Work Order ID 161385

Item ID: 647.7702 **647.7702** Accept ***N900040100*** Setup Start ***NS1***
Revision ID: **B161385** Stop ***NS2***
Item Name: Strut Assembly
Start Date: 5/15/2017 Start Qty: 6.00 **REV. A2** ***6*** Cust Item ID:
Required Date: 5/30/2017 Req'd Qty: 6.00 ***6*** Customer:
Reference: SCHEDULED

ENGINEERING CHANGE NOTICE NO. 05397		SHEET 1 OF 1	
DWG NO. 647.7700	REV: A	PREPARED BY T. CROSS	DATE: 05/02/16
EFFECT ON DWG ☐ INC. ☒ UNING.			
DWG TITLE: STRUT ASSY			
APPROVED BY: ENGR <i>[Signature]</i>	MFG <i>[Signature]</i>	QC <i>[Signature]</i>	EFF: <i>[Signature]</i>
REASON: REVISED DIMENSION			CURRENT ORDER
			ECR: 16-028
			ACTION LIST: 1.

ENGINEERING CHANGE NOTICE NO.

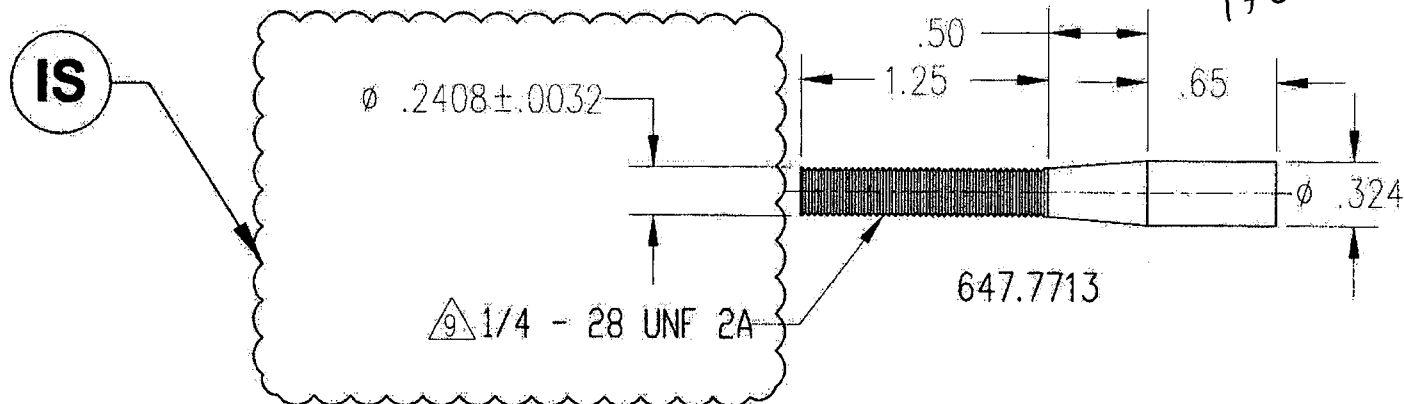
SHEET 2, ZONE D4 IS:

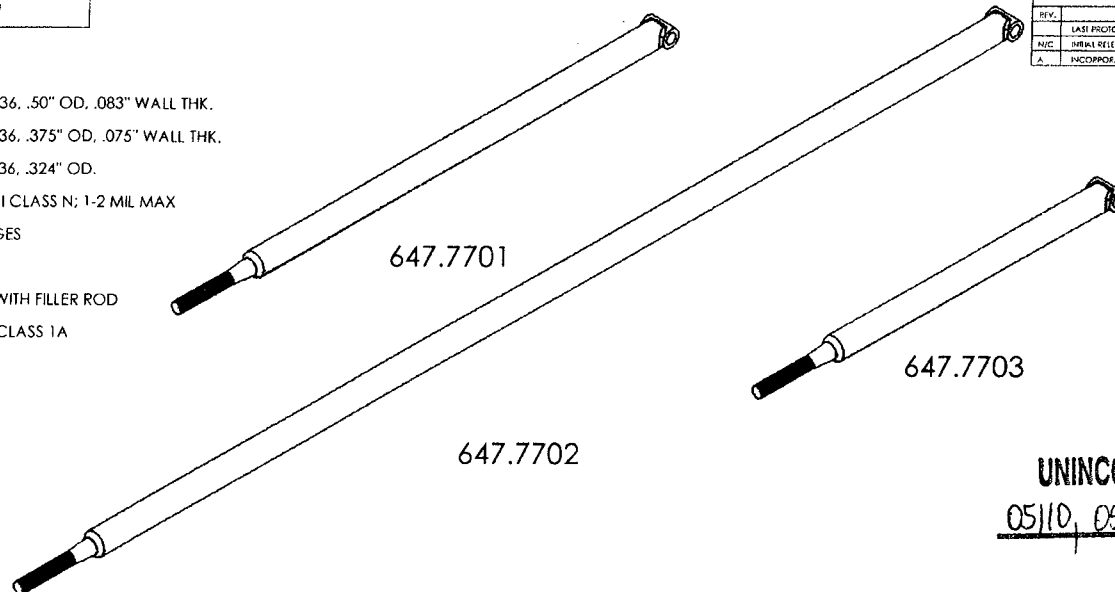
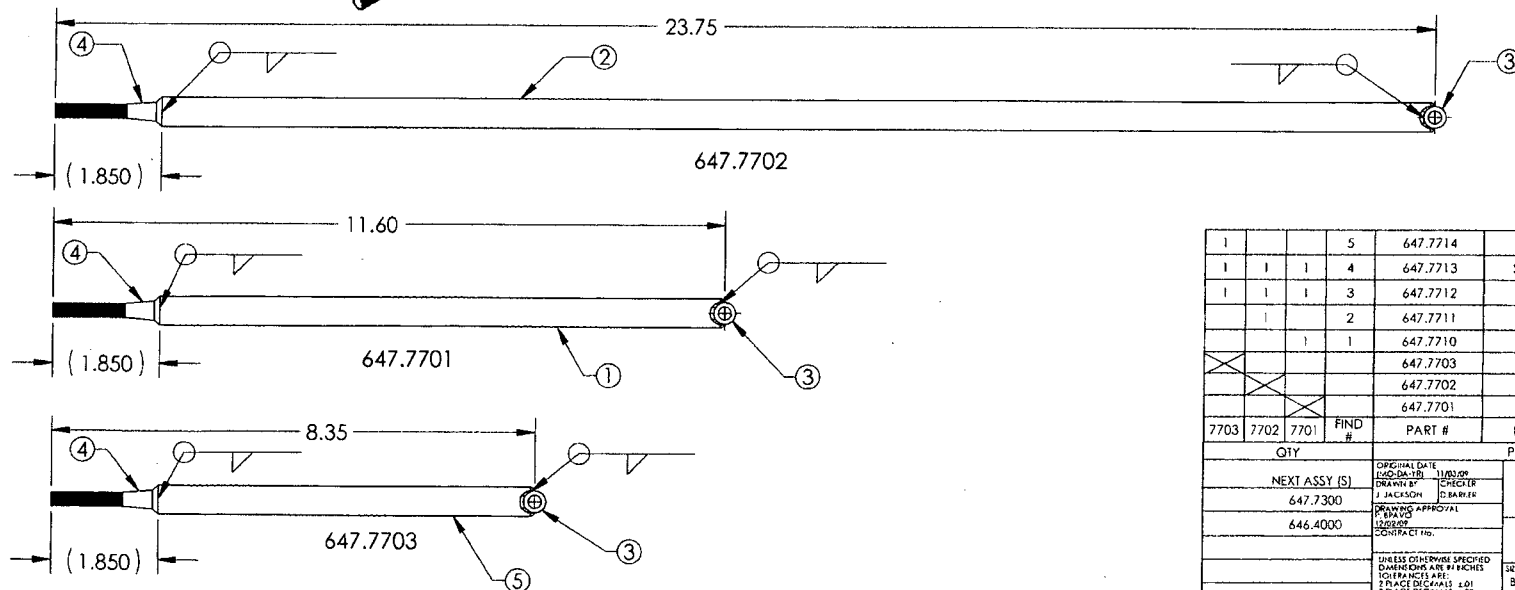
REASON: REVISED FINISH CALLOUT AS PER ECR 15-209

SHEET 1, NOTES IS:

- 1 MATERIAL: 4130 STEEL PER AMS-T-6736, .50" OD, .083" WALL THK.
- 2 MATERIAL: 4130 STEEL PER AMS-T-6736, .375" OD, .075" WALL THK.
- 3 MATERIAL: 4130 STEEL PER AMS-T-6736, .324" OD.
- 4 FINISH: PRIME IAW MIL-P-2337J TYPE I CLASS N; 1-2 MIL MAX
5. DEBURR AND BREAK ALL SHARP EDGES
6. IDENTIFY IAW MPP-120.
- 7 WELD IAW MIL-STD-2219. TIG WELD WITH FILLER ROD
- 8 FINISH: CAD PLATE IAW QQ-P-416F CLASS I TYPE II
- 9 MASK THREAD PRIOR TO FINISH
